Service Note		
Products	Description:	Service note no.
VoiceSolo FX150	Improvement for audio quality	SNo-T208

Placement of L7 and L12

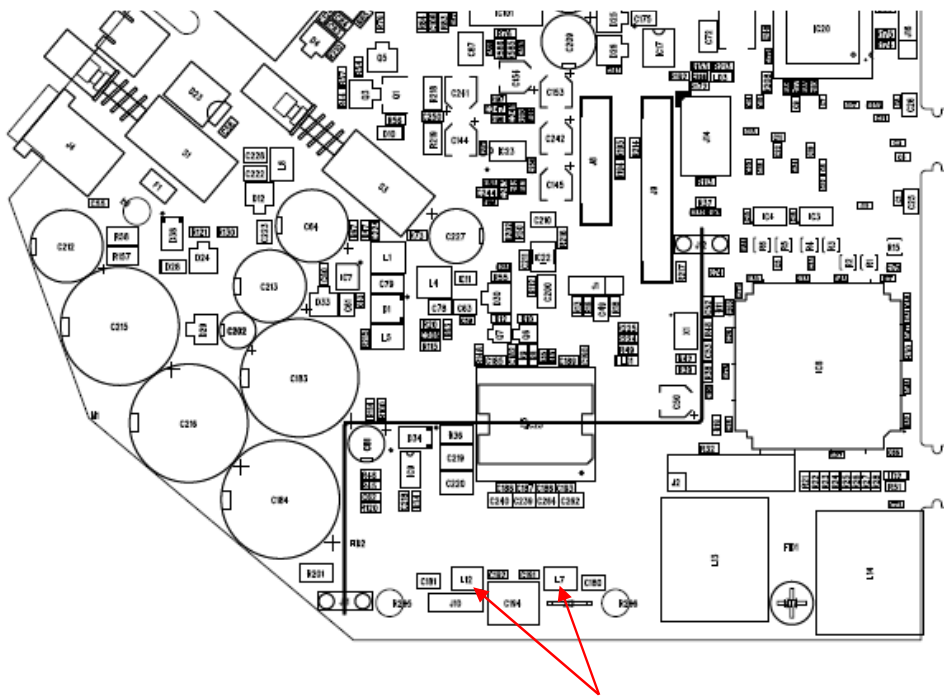
Some customers have experienced issues with buzzing or low frequency speaker noise

If a product comes in for service with symptoms like above mentioned the problem can most likely be solved by exchanging L7 and L12 in the power amplifier section with ultra low ohmic resistors.
